ANSTY GARDEN COMMUNITY,

DESIGNERS RESPONSE

REPORT REF NO. 2207280-R14B

- 1.6 The following drawing have been prepared to incorporate the findings of the RSA:
- **ACE Drawing 2207280-004F** – Proposed Roundabout Western Access (A272)

Drawing Number: **2207280-004** Rev C

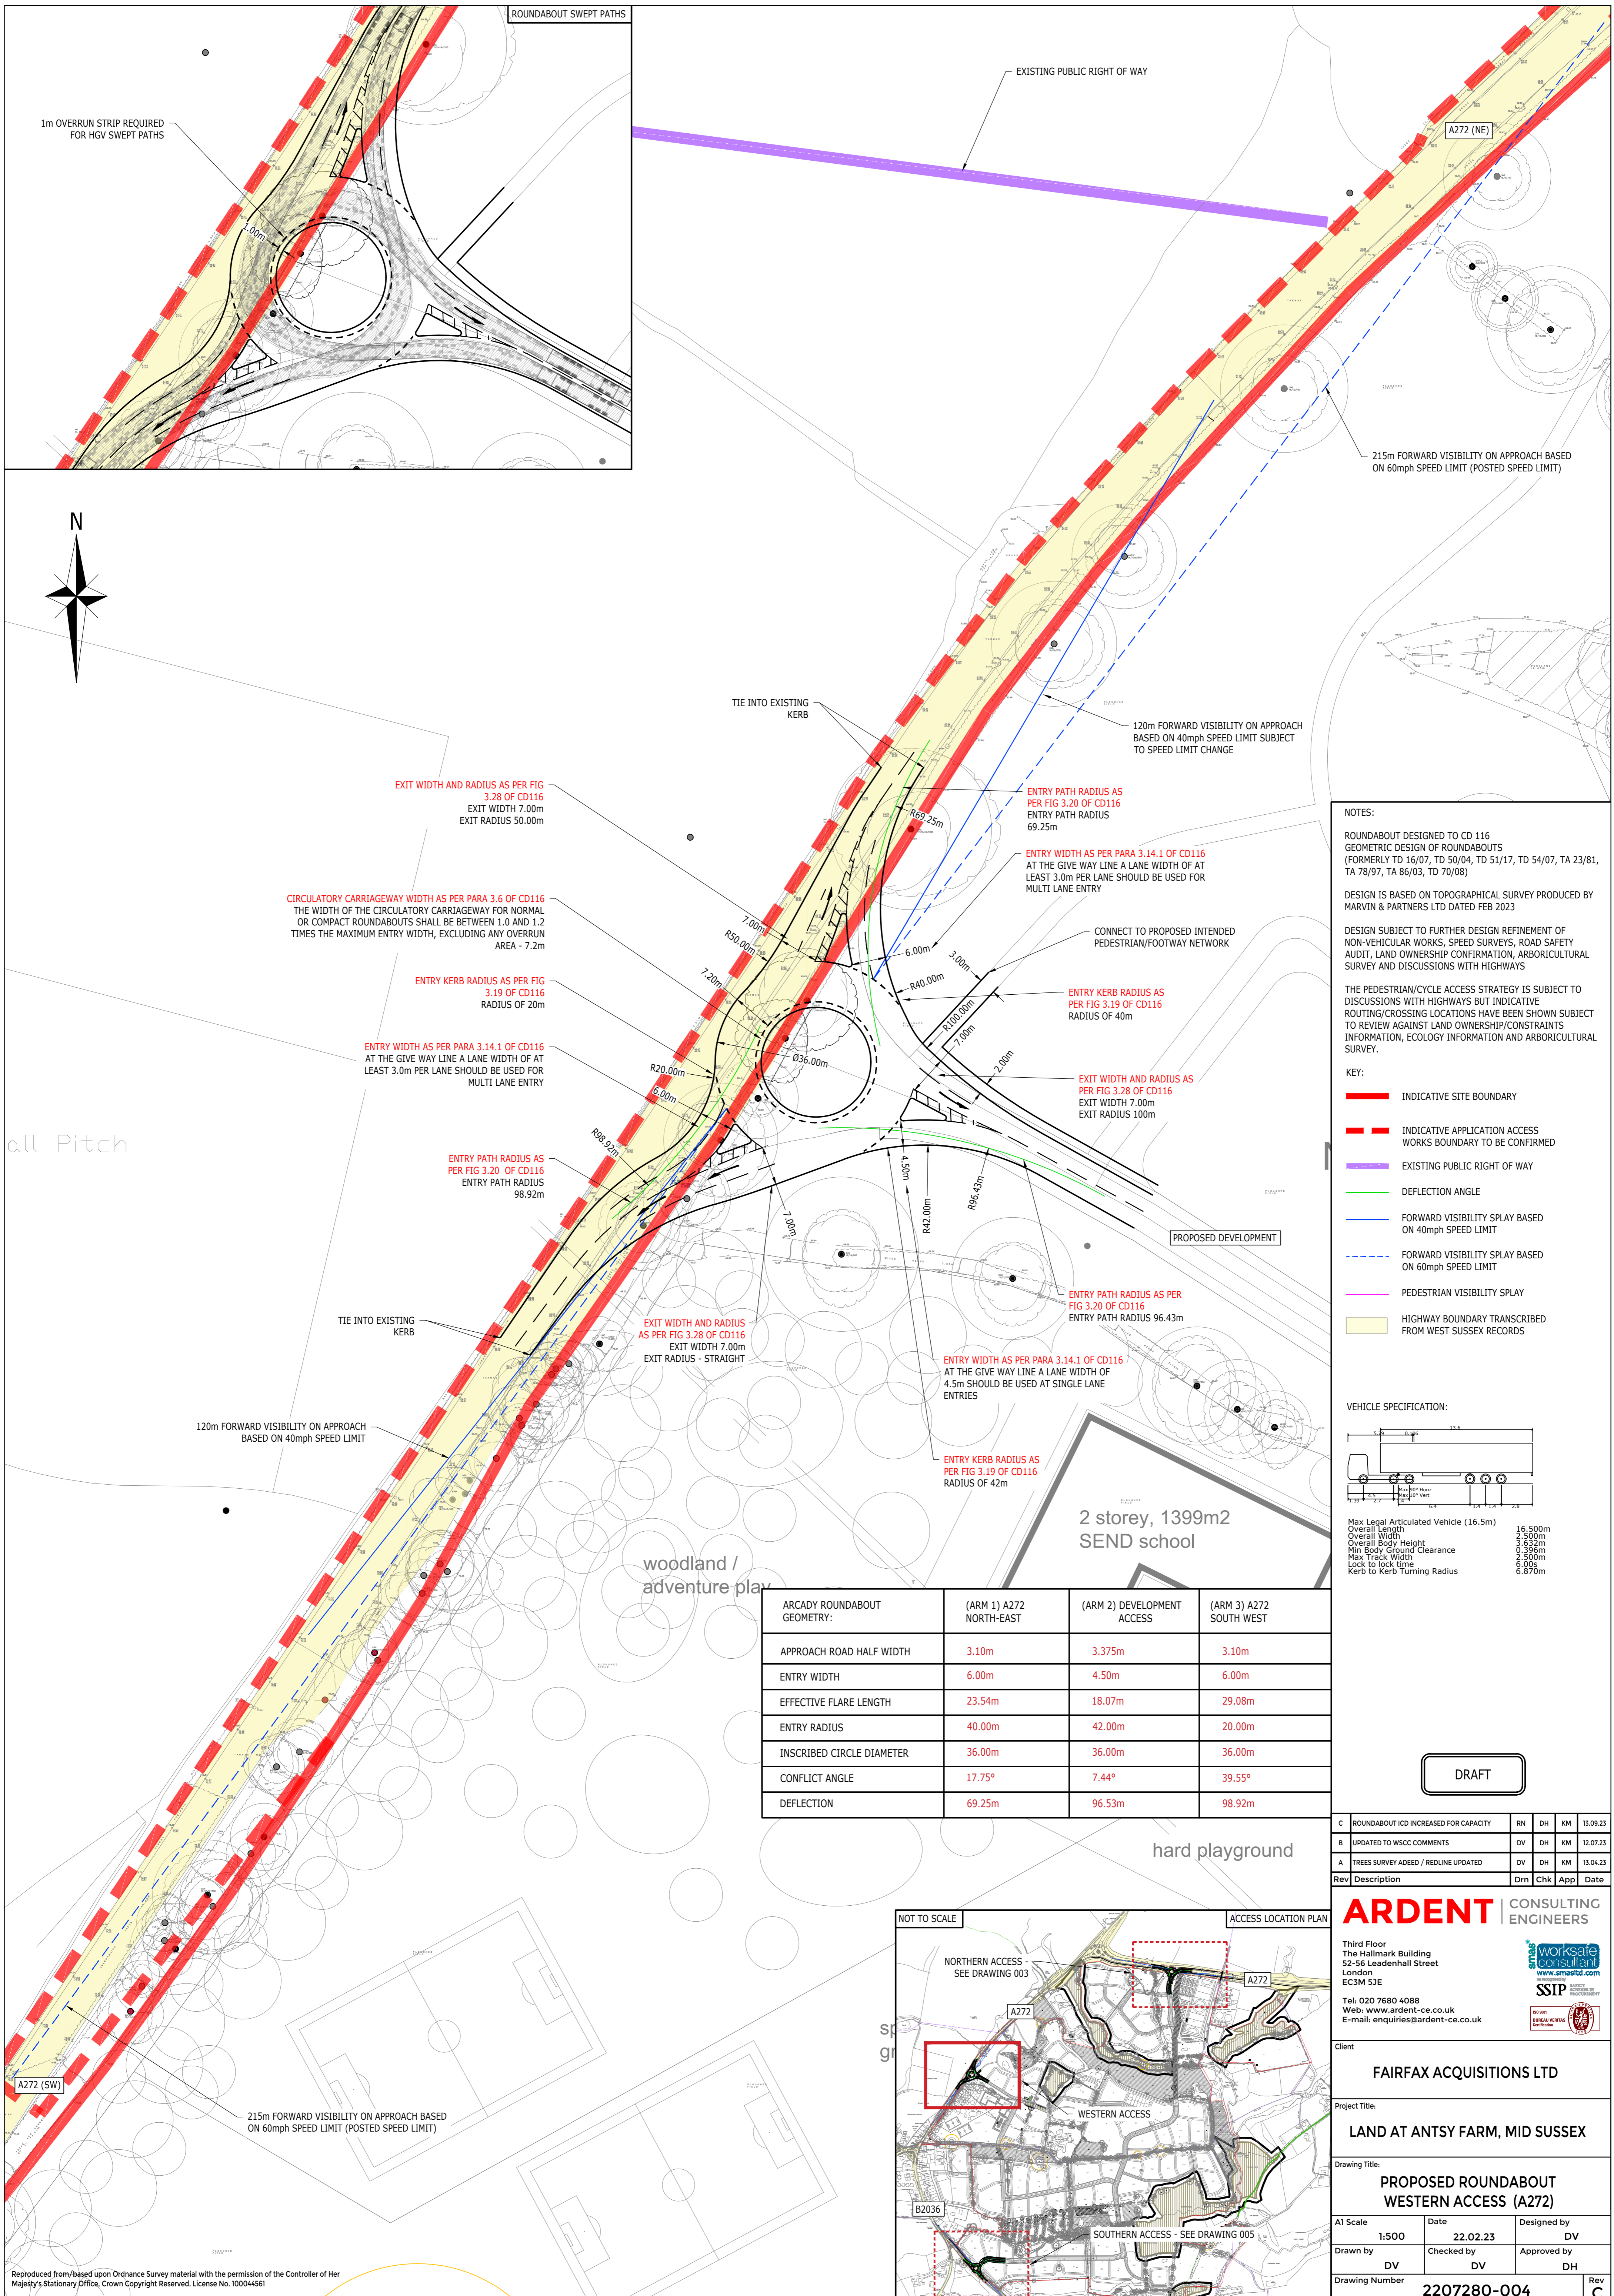
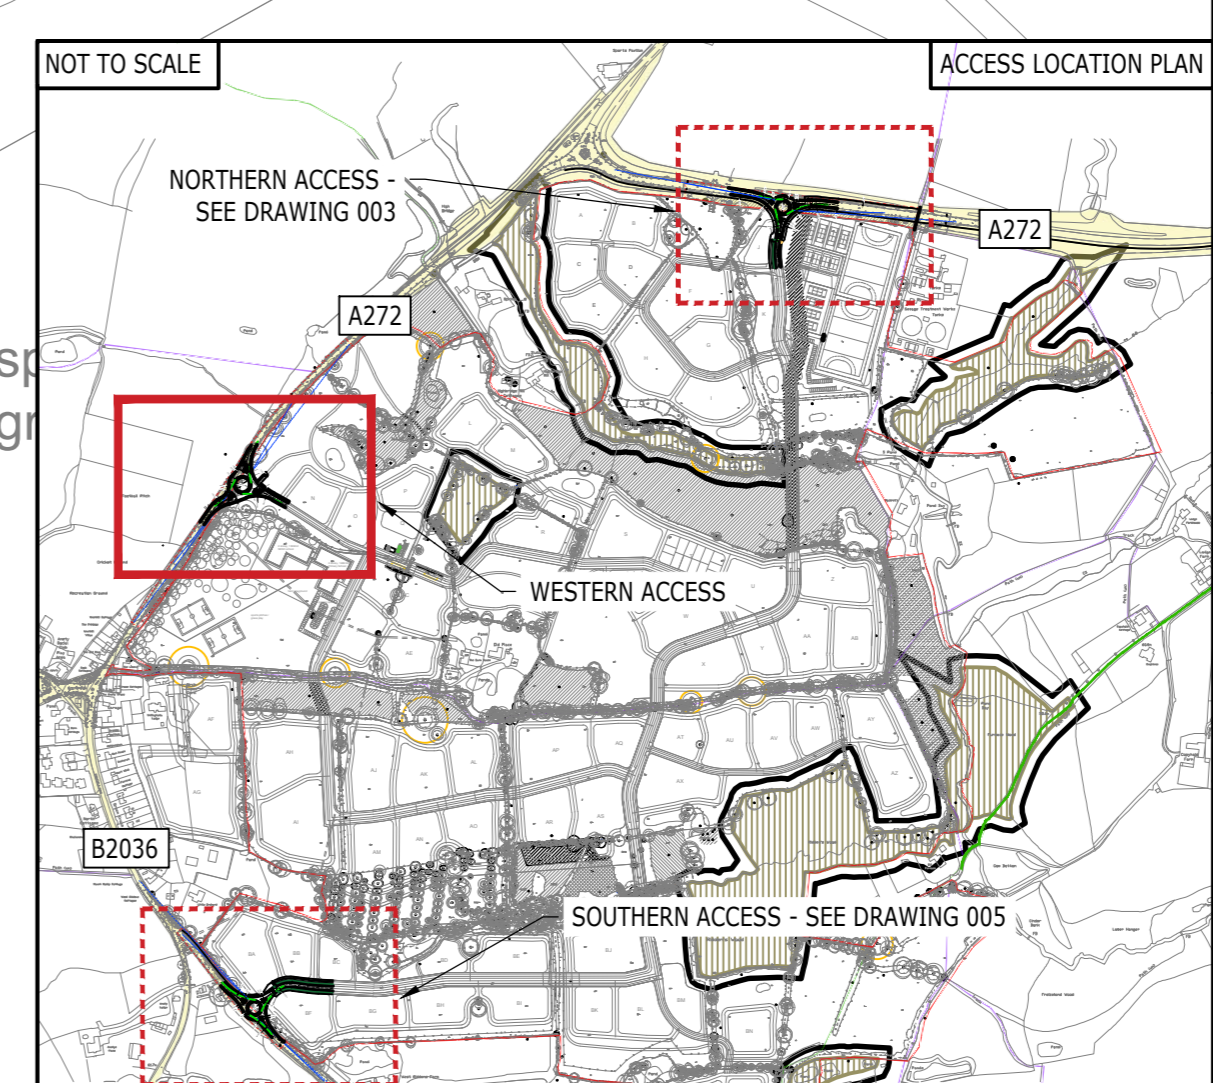
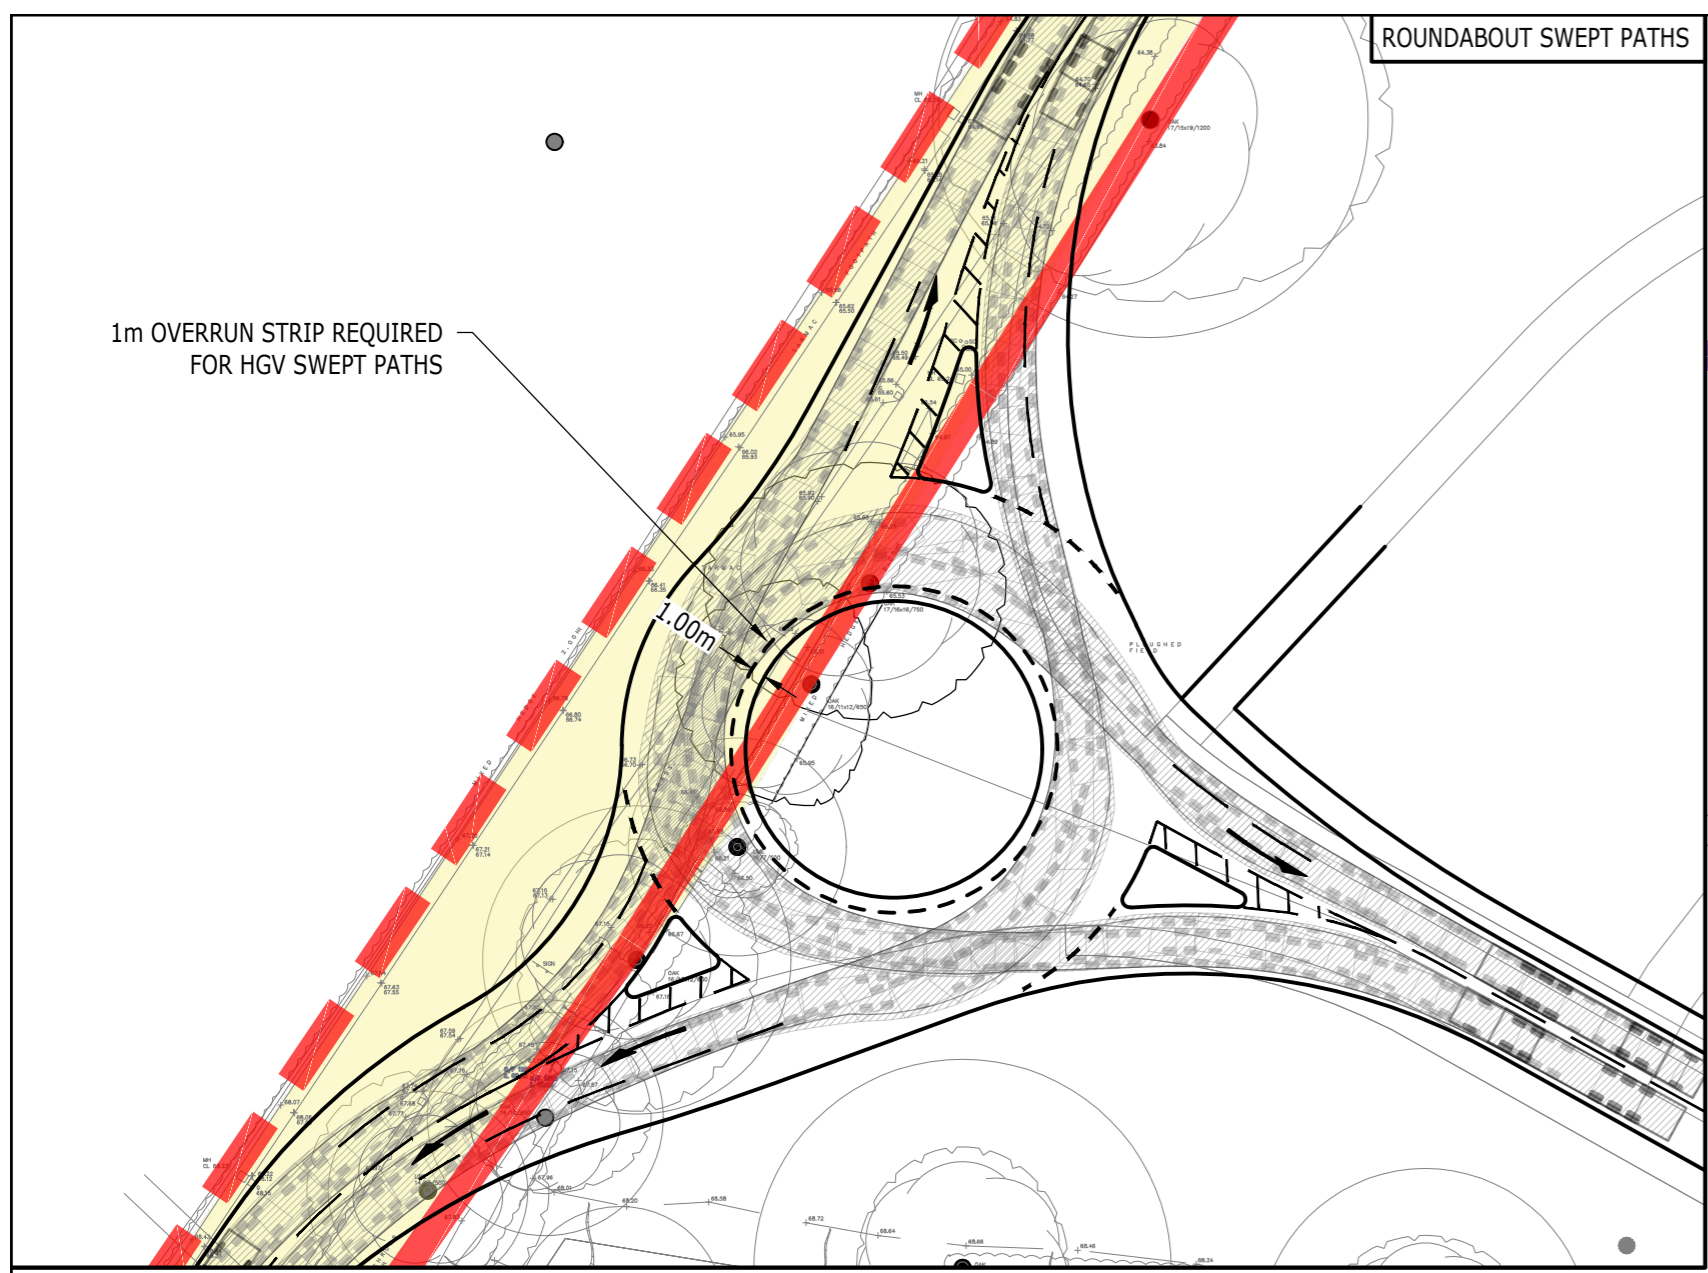
3.1.1 PROBLEM

Summary: Insufficient construction details could lead to overshoot or rear end shunt collisions.

The proposals do not include the introduction of anti-skid surfacing or detail the Polished Stone Value (PSV) to be used on the approaches to the roundabout and surfacing as part of the scheme. Surfacing with an insufficient PSV could lead to overshoot or rear end shunt collisions.

It is recommended that high friction surfacing should be provided on all the approaches to the roundabout and that the PSV of all surfacing should be provided for assessment a Stage 2 Safety Audit.

3.2.2 PROBLEM

On the southwest bound approach to the roundabout SSDs have been provided for assessment. However, there is concern that the SSDs pass over non-highway land. Vegetation or landscaping features in these splays could restrict visibility, where insufficient visibility may increase the risk of junction related or shunt type collisions at the roundabout.

It is recommended that a suitable covenant should be arranged to ensure that the splay is not affected by planting or landscaping features.

3.2.3 PROBLEM

On the northwestern bound approach to the roundabout no SSD has been provided for assessment. There is concern that the SSD could pass over non-highway land. Vegetation or landscaping features in this splay could restrict visibility, where insufficient visibility may increase the risk of junction related or shunt type collisions at the roundabout.

It is recommended that the SSD should be supplied for assessment and that they should be within the adoptable highway, or that a suitable covenant should be arranged to ensure that the splay is not affected by planting or landscaping features.

3.2.4 PROBLEM

The proposed roundabout is located on the A272, where there is a fall from the southwest to the northeast. At this early stage no vertical alignment details were provided for assessment. There is concern that inappropriate vertical profiles could restrict visibility at the junction, which may lead to side impact collisions or loss of control collisions.

It is recommended that vertical alignment details should be provided for assessment at Stage 2 Safety Audit.

3.2.5 PROBLEM

On all arms, the proposed exits from the roundabout are two lanes wide, narrowing to one lane over a short merge length. The layout encourages aggressive drivers to overtake a slower moving vehicle over a relatively short distance. There is concern that such overtaking manoeuvres could lead to side swipe collisions, rear end shunts or loss of control collisions, particularly as one of the of the merges is on a bend.

It is recommended that the exits from the roundabout should be restricted to one wide lane.

3.3.1 PROBLEM

No details of expected flows and the capacity of the roundabout have been provided for assessment. Insufficient capacity could lead to congestion where excessive queuing at the roundabout could lead to driver frustration and the use of inappropriate gaps, further unbalanced flows could lead to entry problems on to the roundabout. This may lead to rear end shunt or side impact collisions.

It is recommended that the roundabout should operate without excessive queuing and with balanced flows and that an ARCADY or similar model should be provided for assessment.

3.3.2 PROBLEM

The angle of entry was provided for assessment, where for northeastern and development arms the angle of entry was less than twenty degrees. Low angles of entry could force drivers to look over their shoulders or use their mirrors to merge with circulating traffic, increasing the risk of side impact collisions.

It is recommended that the angle of entry should lie between 20° and 60°.

3.5.1 PROBLEM

At this early stage no details of street lighting have been provided for assessment. A lack of lighting could increase the risk of loss of control and side impact collisions at the roundabout during the hours of darkness.

It is recommended that street lighting should be checked with the Highway Authority's street lighting team and that a plan showing the light distribution should be provided for assessment at Stage 2 Safety Audit.
